Grain Store
Land adjacent to Prescott Road (North of Red House Farm)

Highway Comment

To provide response to highway officer's observations in respect to planning application 23/02389 seeking amendments to the existing access and landscaping scheme of approved agricultural grain storage building approved under application 23/000005/AGR.

Date:	12 th February 2024
To:	Planning Services
Planning App. No:	23/02389/FUL
Proposal:	AMENDMENTS TO EXISTING ACCESS AND LANDSCAPING SCHEME OF APPROVED AGRICULTURAL GRAIN STORAGE BUILDING (APPLICATION 23/00005/AGR)
Location:	Land Adjacent To Prescott Road, North Of Red House Farm And South Of Cronton Road, Cheshire, Widnes, WA8 5PS,

16.5m articulated vehicle left in/right out maneuver

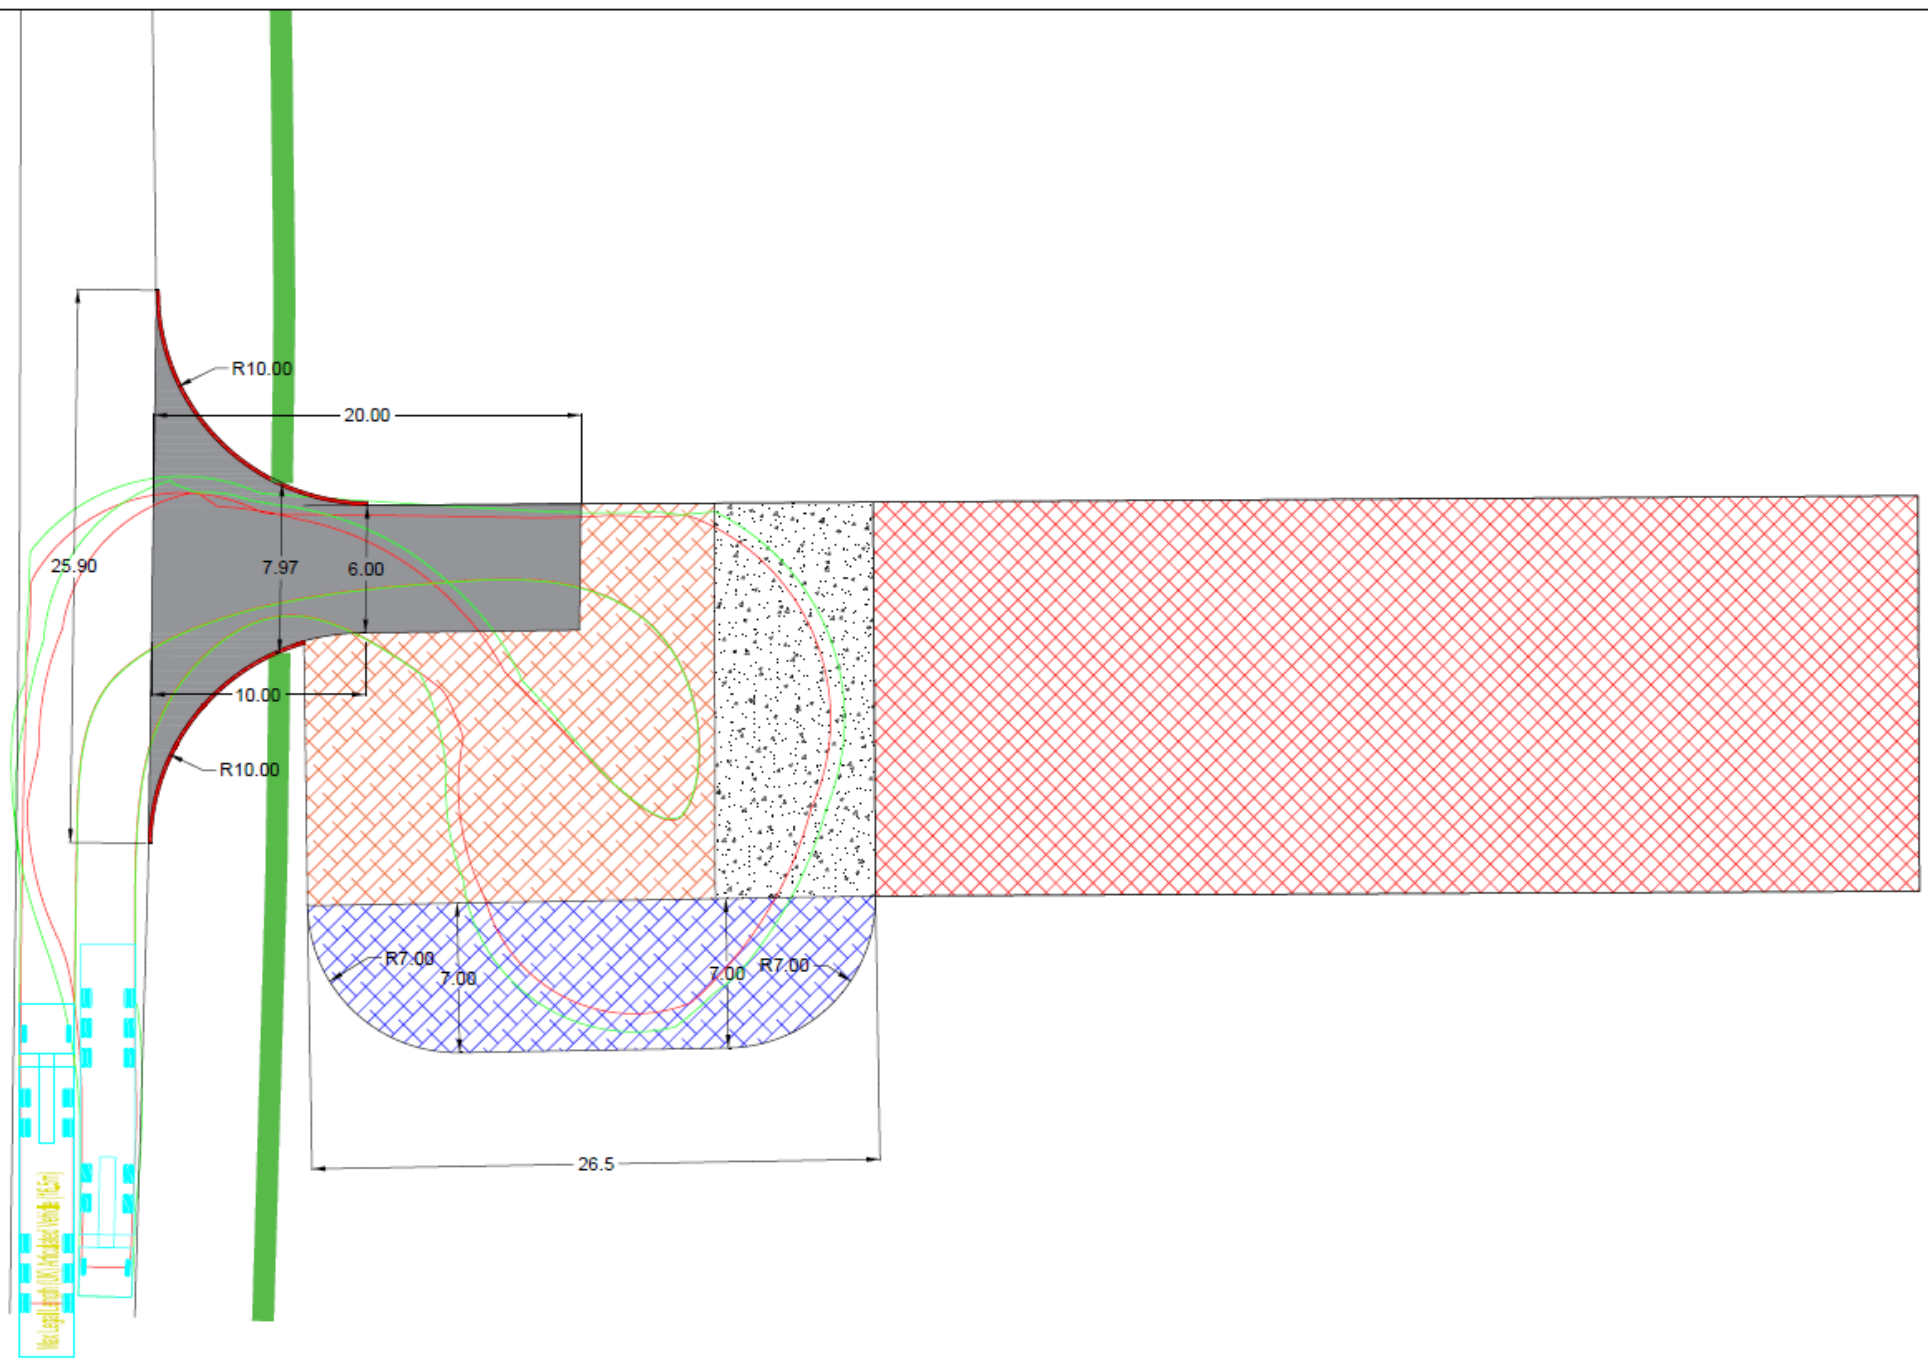
Highways note the additional information including the swept path drawing which shows additional turning area and access ~~bellmouth~~. Unfortunately, the swept path plots have been drawn overlayed and contiguous which makes it impossible to discern the different manoeuvres. The plots will need to be presented separately on a new plan. It is noted however that the 6.5m radii of the access, combined with a 6m access width, is insufficient to allow turning into the site without a stationary turning of the steering on the adopted highway as shown in the excerpt below (highlighted yellow). Ordinarily, accesses suitable for HGVs will require 10m radii, and the evidence presented to date corroborates this. A modification to the design will be required.

- 2.7 Concern has been raised regarding the swept path drawings and the continuity of movement of the grain lorry whilst accessing the site; the swept path analyses have been re-run to reflect the increased entry radii, continued forward movement of the vehicle has been ensured. Concerns were also expressed regarding the confused appearance of the swept path diagram; simplified individual movements are presented separately in the appendices to this report.

16.5m articulated vehicle right in/left out maneuver

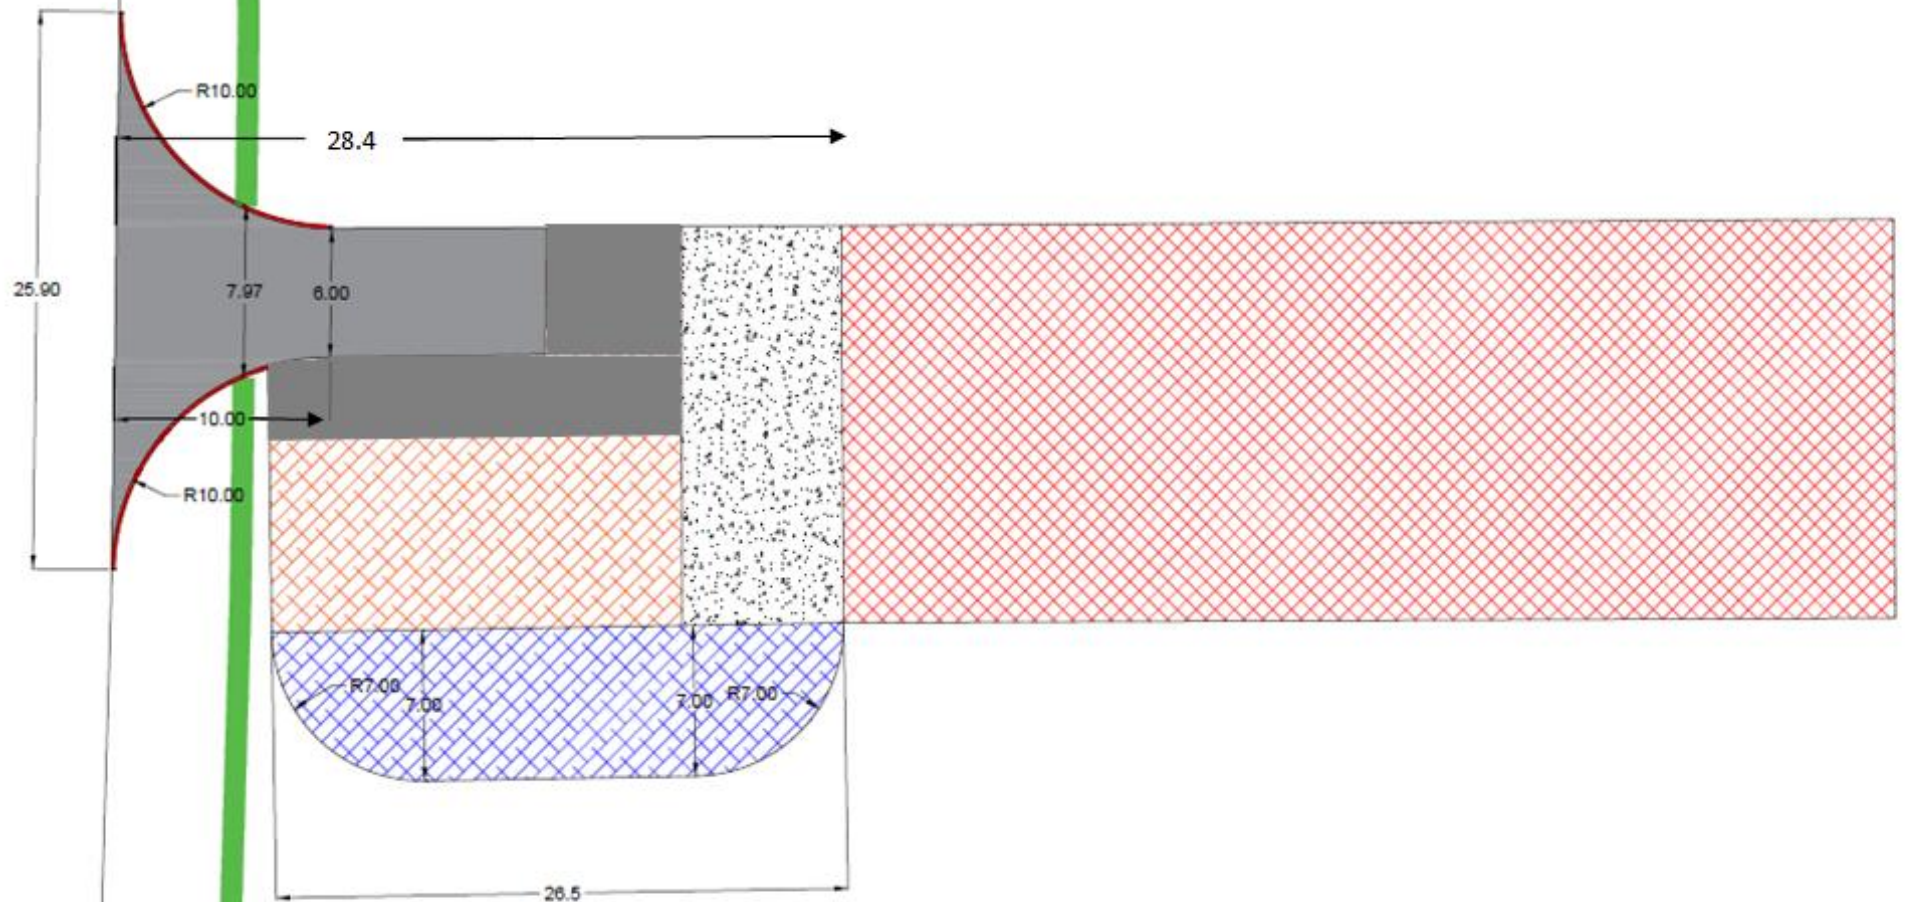
As noted previously, the proposed gates will need to be relocated to at least 18m from the carriageway to allow the HGV to pull clear of the carriageway whilst the gates remain closed and another area of at least the same length will need to be hard surfaced to prevent track out of debris from the turning area.

In order to prevent hardcore being tracked onto the carriageway, particularly with maximum turning movements being carried out on the hardcore/road planings surface, the mouth of the gateway (between the carriageway and the gates),

- 2.8 The extent of hard surfaced area has been increased to reduce the risk of debris being brought onto the highway.

Hard paving extended
